Technical design note

Project name	Ancoats Garden		
Design note title	Discharge of Planning Conditions 5 & 9		
Document reference	C-24134-HYD-XX-XX-TN-C-0001		
Author	Josh Booth		
Revision	Po4		
Date	3 August 2023	Approved	✓

1. Planning Conditions 5 and 9

*C24134-HYD-XX-XX-DR-C-0501_P08_United Utilities
Diversion - Proposed Drainage Layout*

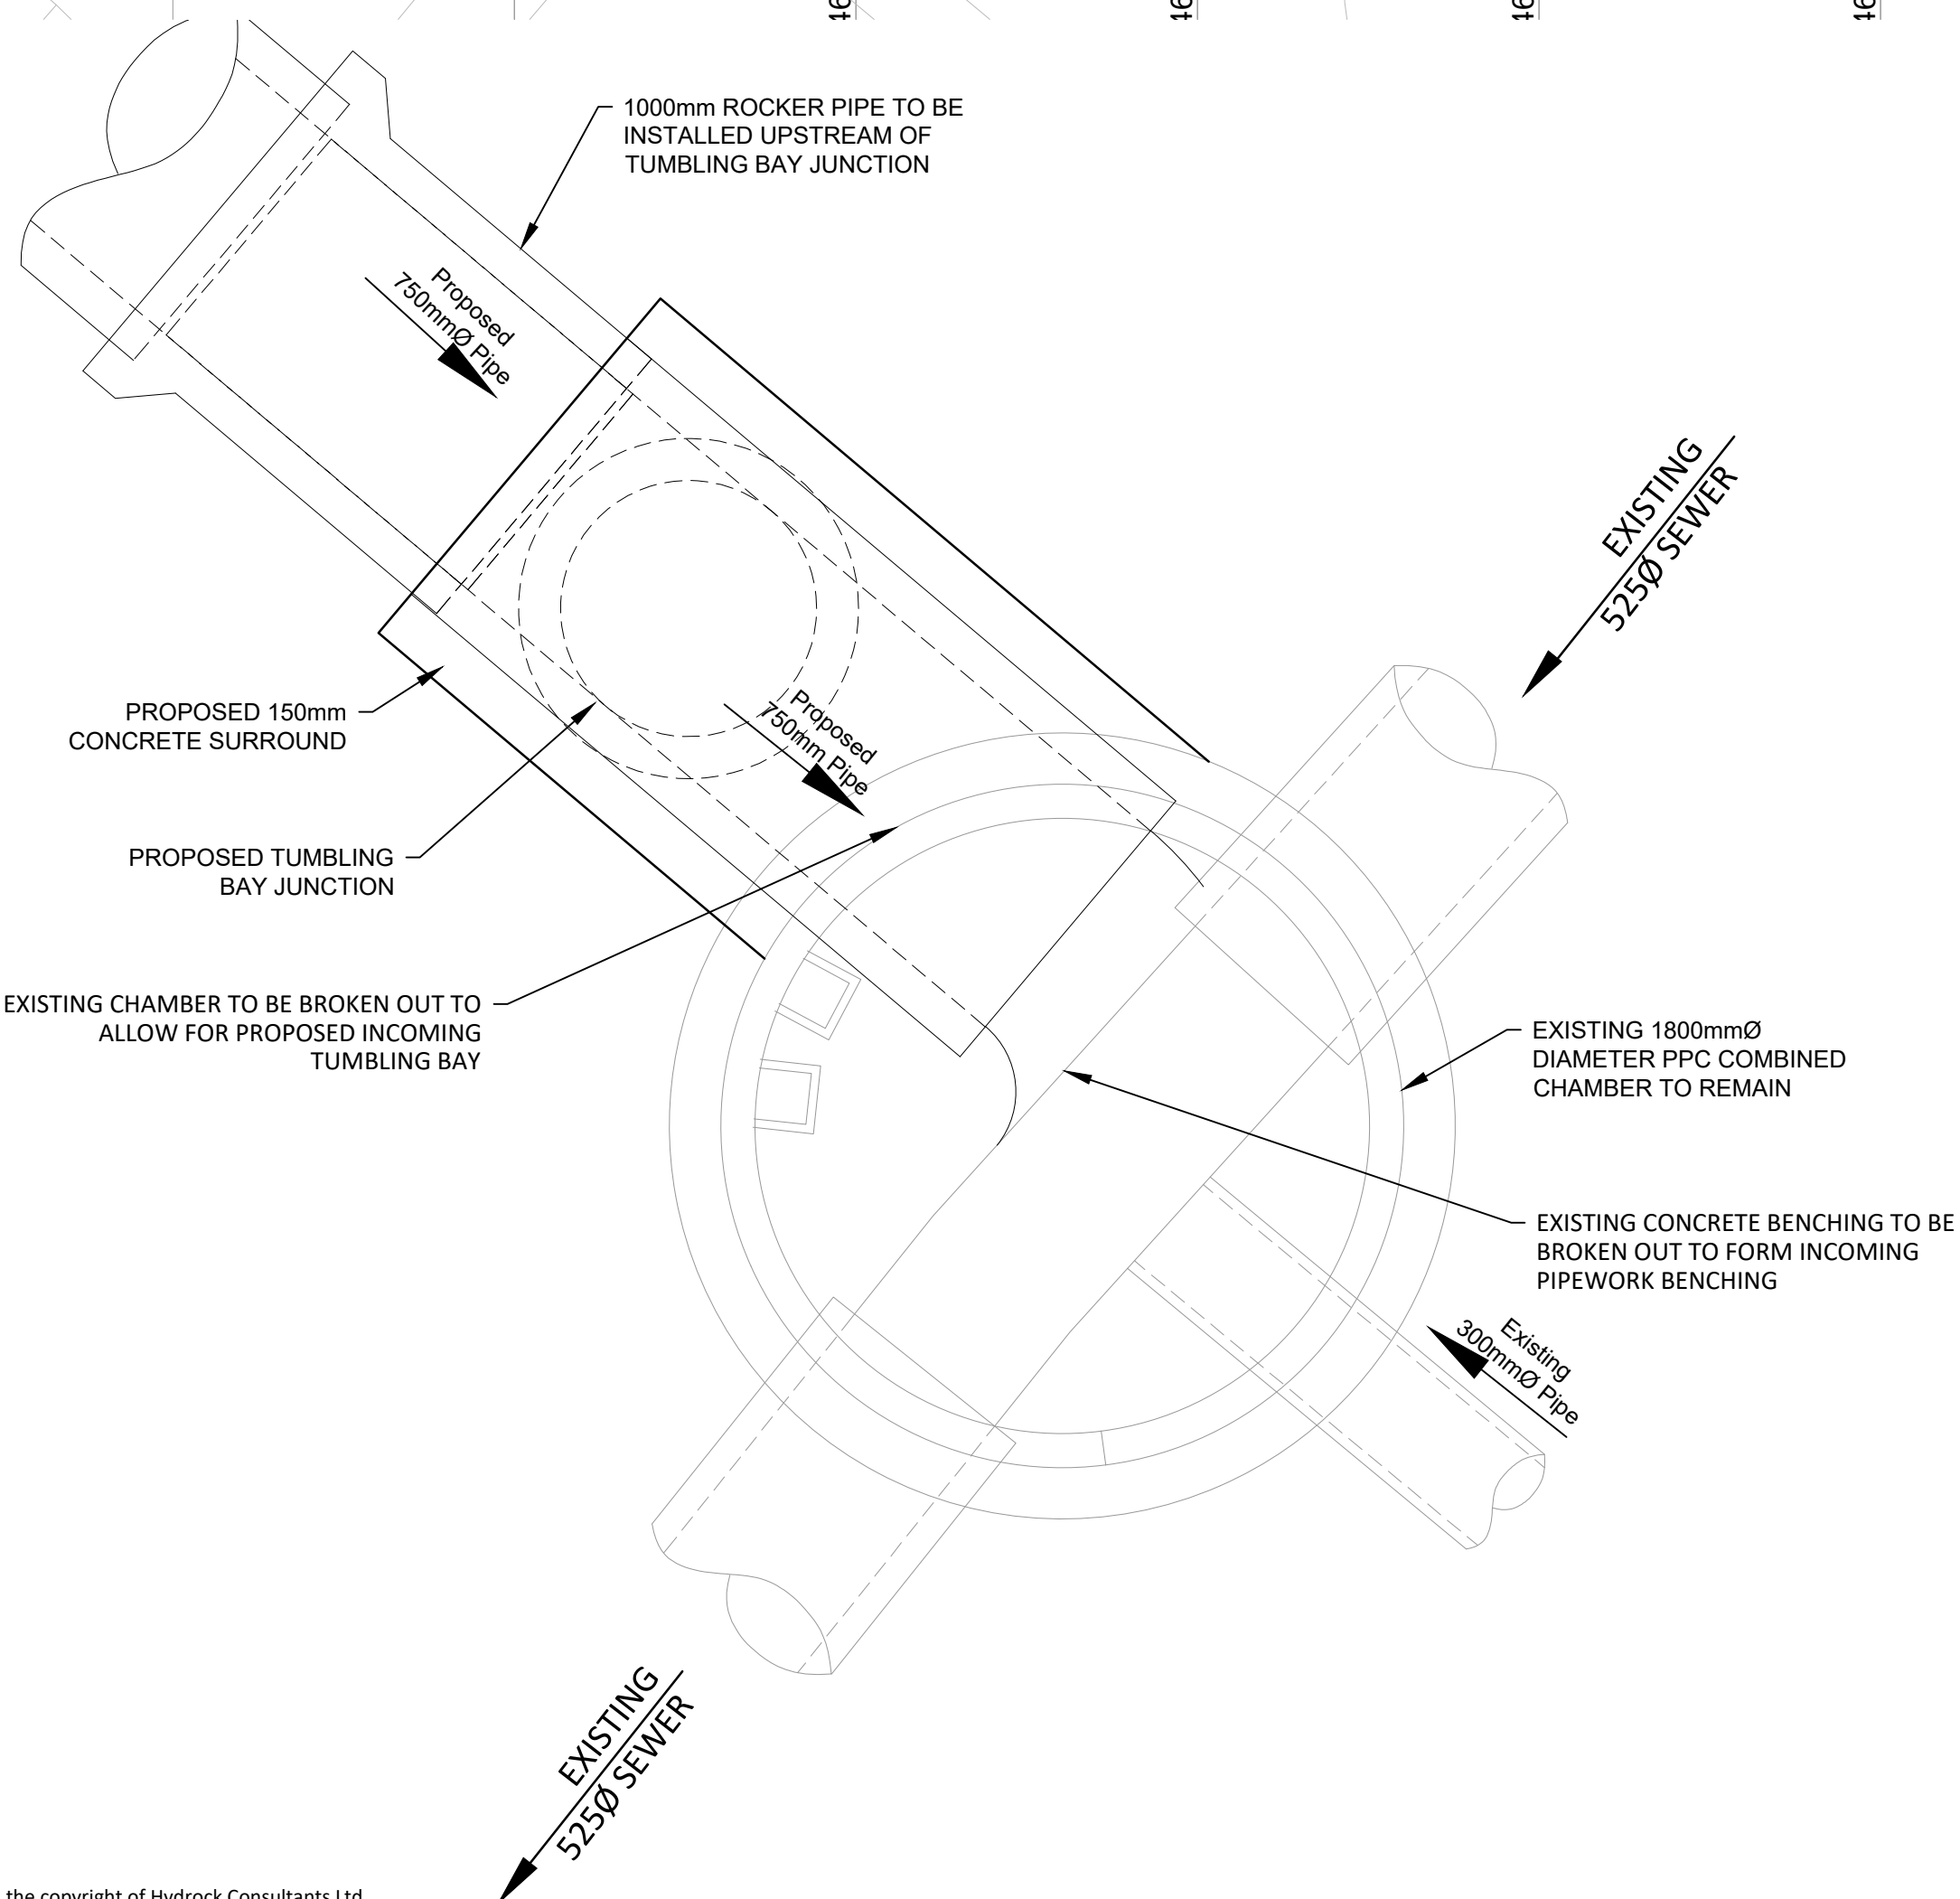
Following construction of the on-site drainage it was identified that the existing combined manhole to be connected to was too shallow for a gravity connection. This was resolved by lowering of the UU sewers within Bendix Street under a Section 185 Agreement. Hydrock were appointed to produce engineering drawings indicating the excavation and re-constructing of the existing United Utilities public combined sewer, creating a deeper connection chamber that will allow a gravity connection from the proposed development.

The proposed diversion works to the Public Sewer have been agreed with United Utilities, and the construction has been completed on site. The approved design can be found within Appendix B, and acceptance correspondence can be found within Appendix C.

C24134-HYD-XX-XX-SK-C-1000 - Drainage Picture Locations

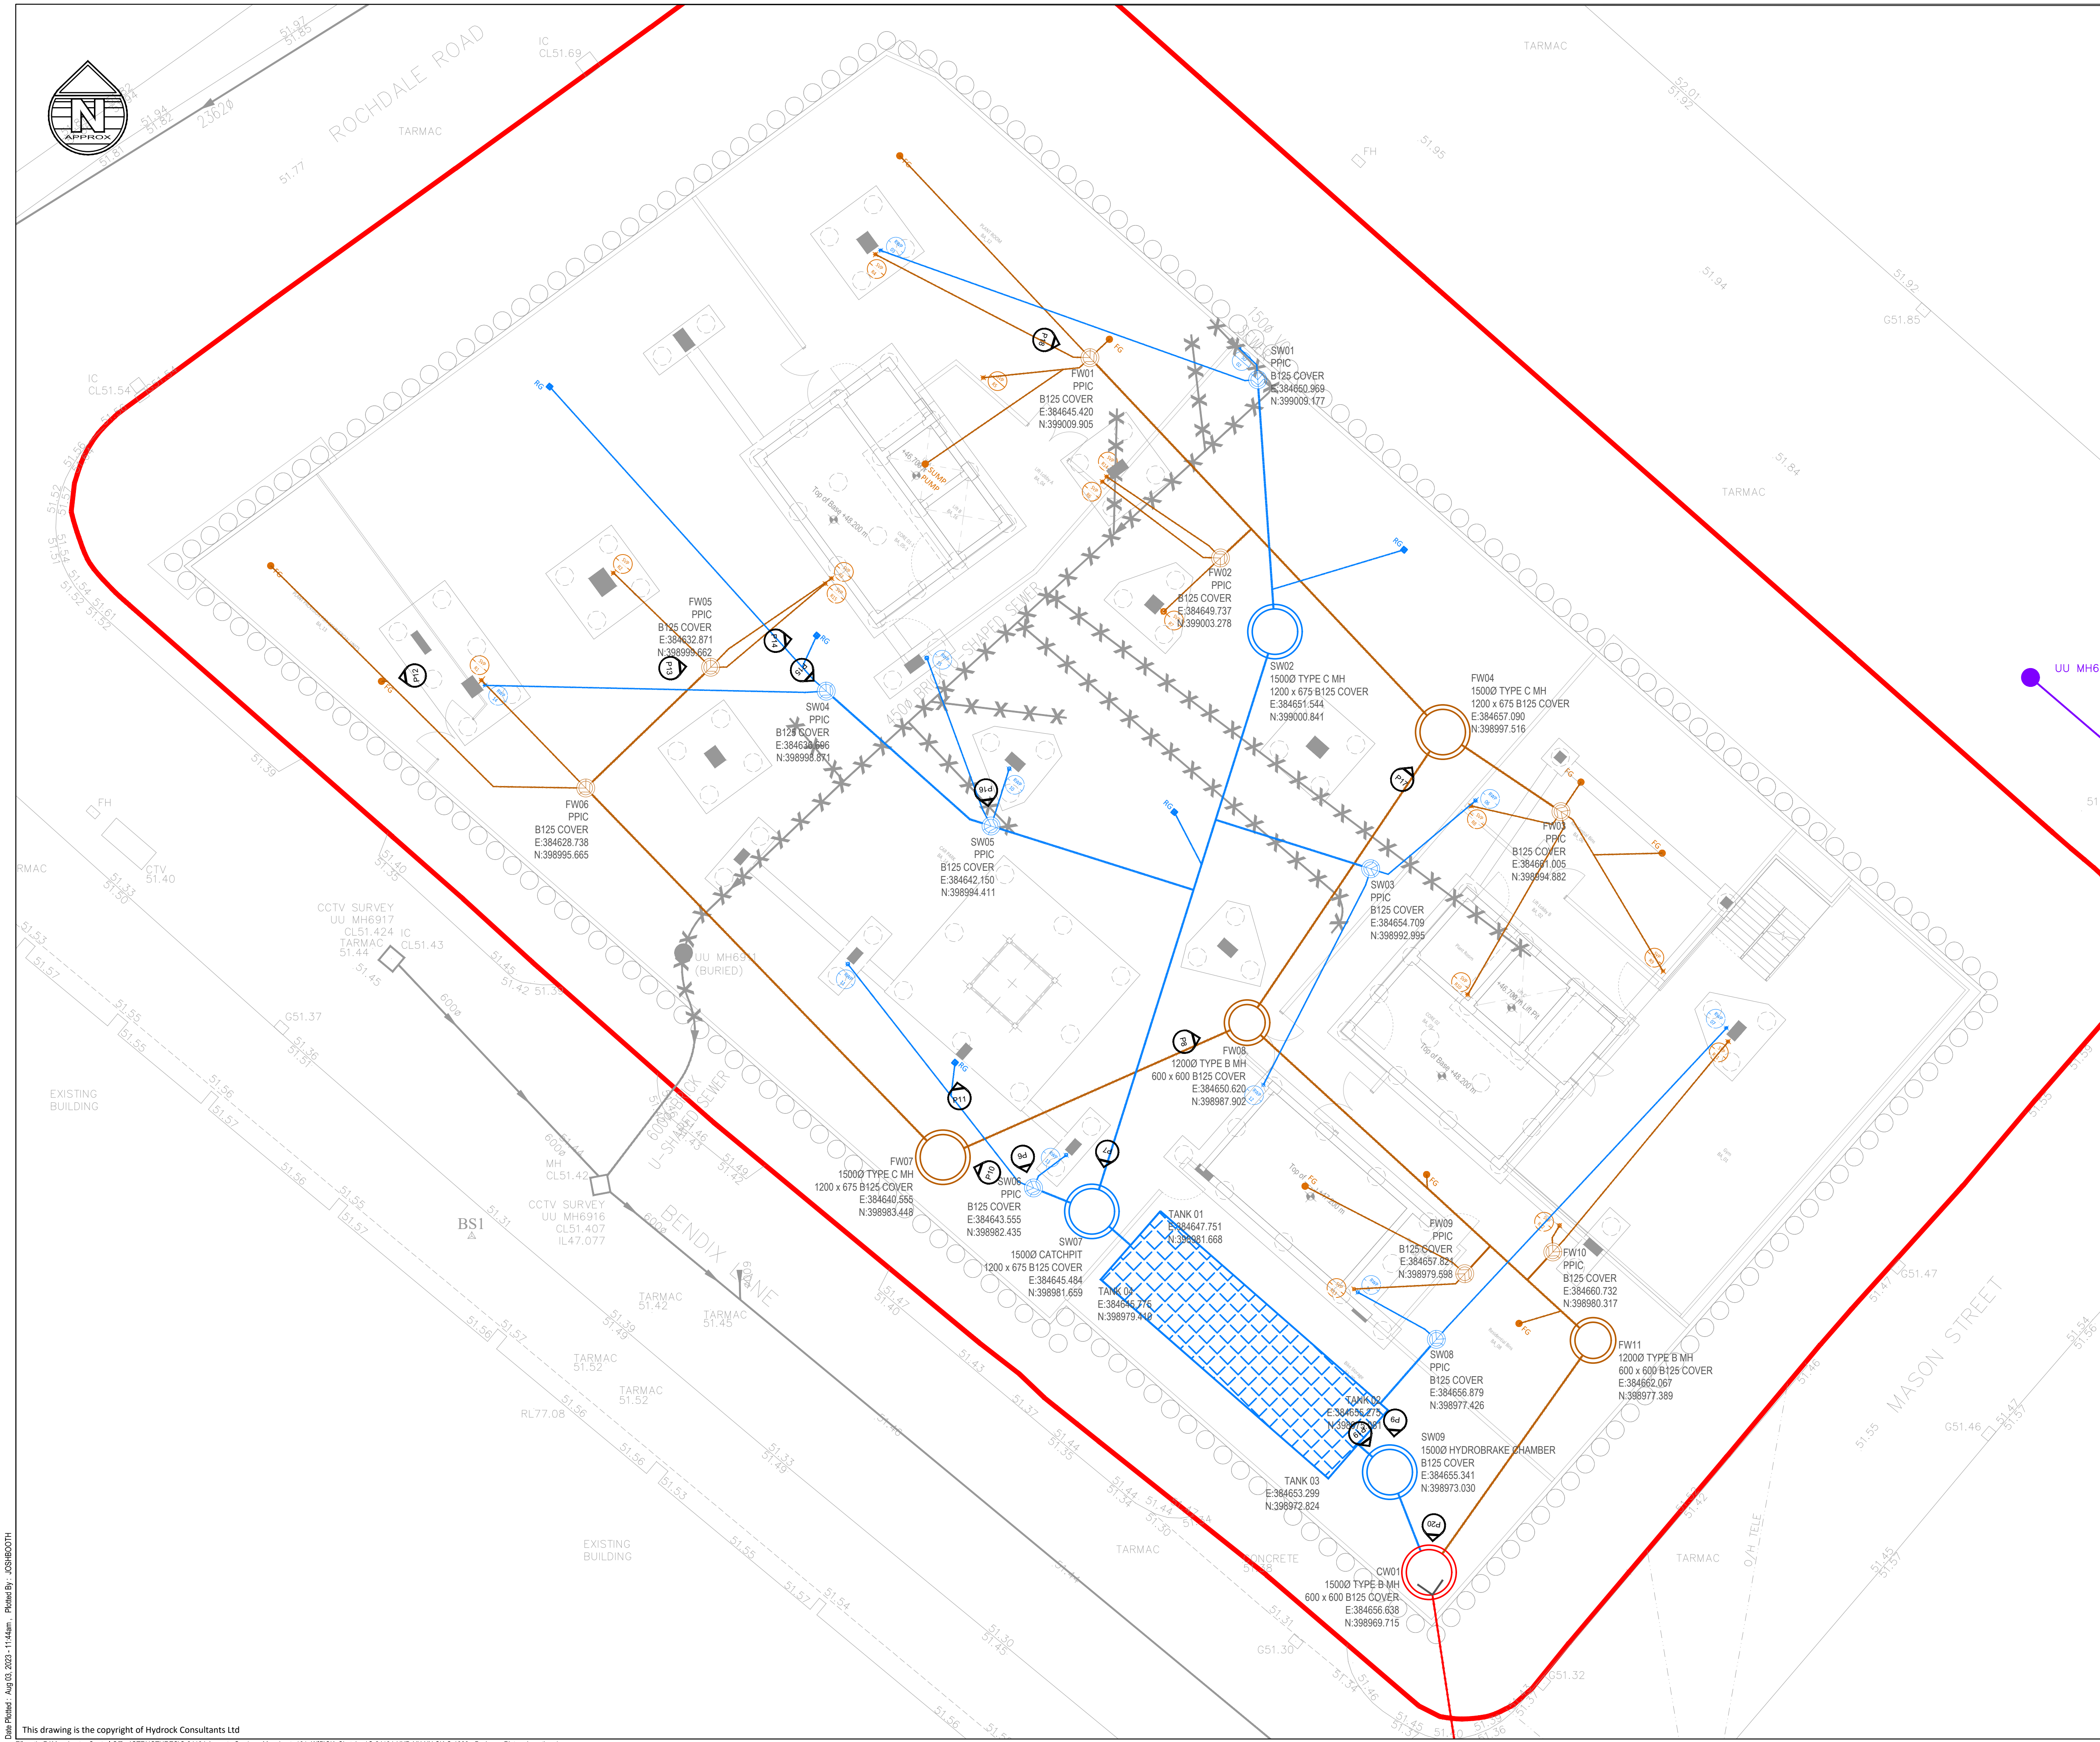
- The verification report does not include photos of the flow control (this is not visible in the photo provided). Please submit photographic evidence of this component.

The location of the photos is shown on the drawing in Appendix E.

C24134-HYD-XX-XX-DR-C-0530_As-Built Drainage Records

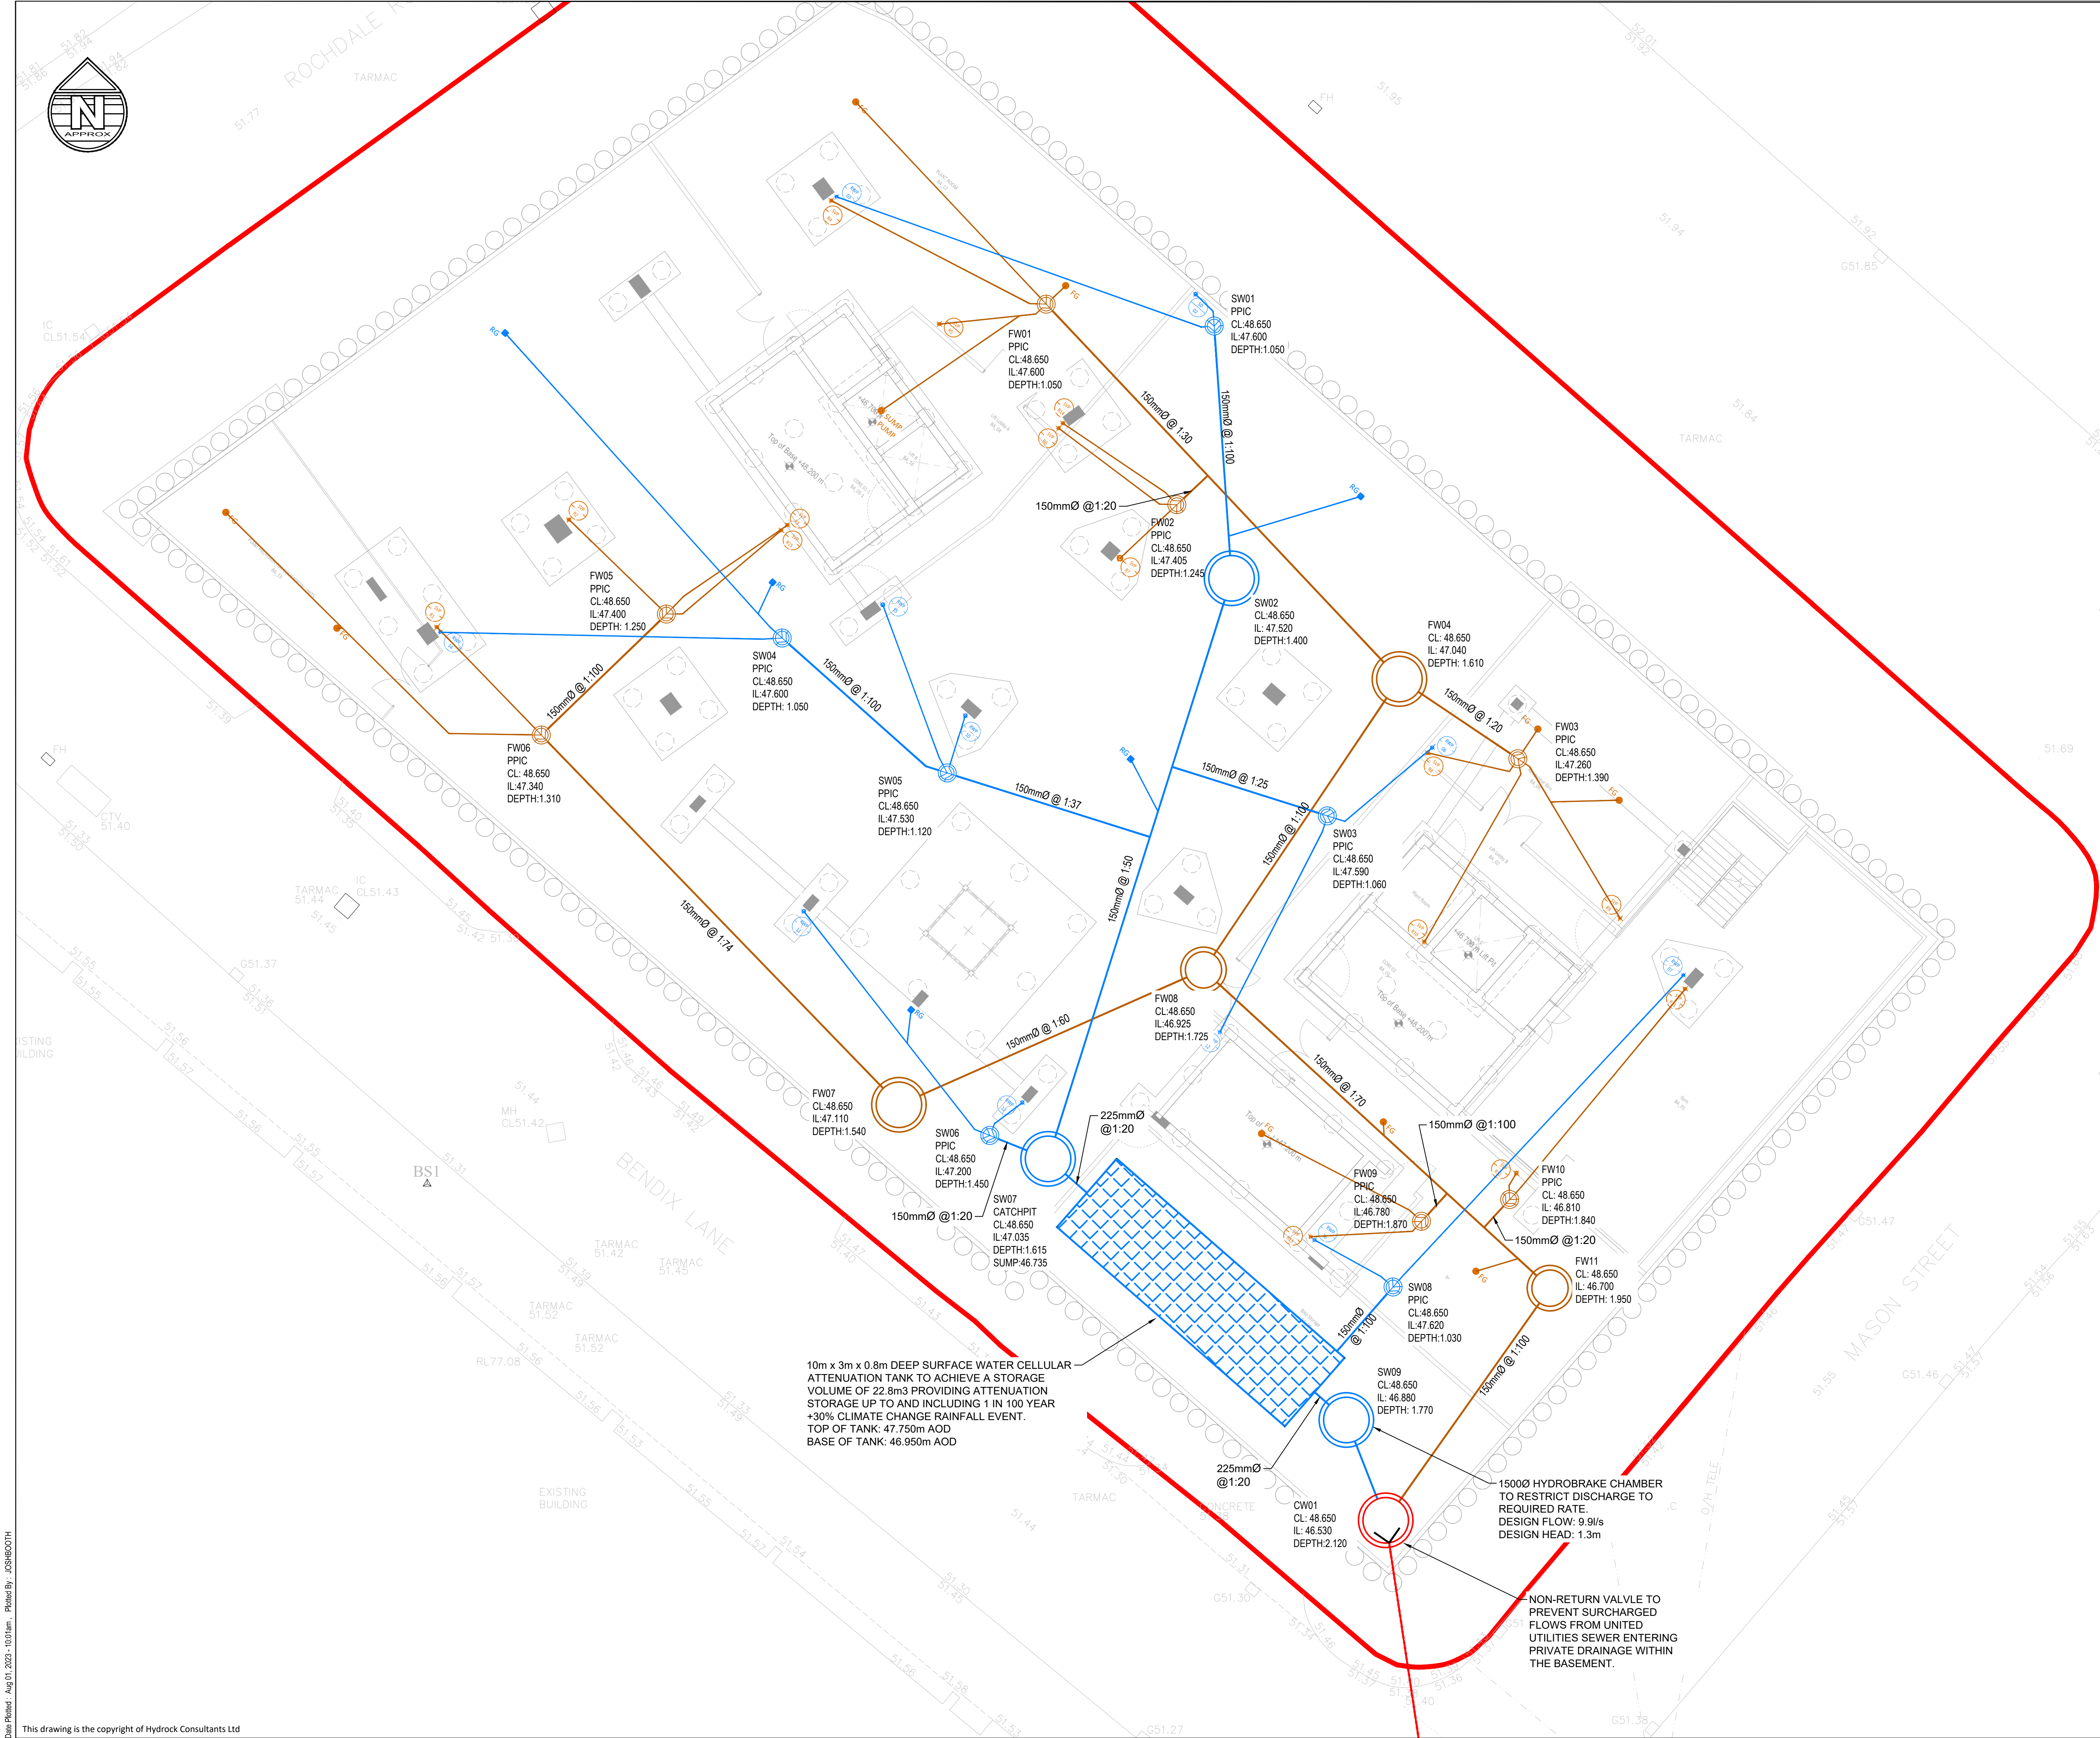
- We would expect a PDF as-built engineering drawing, including cover levels, invert levels, flow control restrictions and attenuation details. Rather than an image demonstrated within figure 6.

The as-built drawing C-24134-HYD-XX-XX-DR-C-0530 is included in Appendix F.
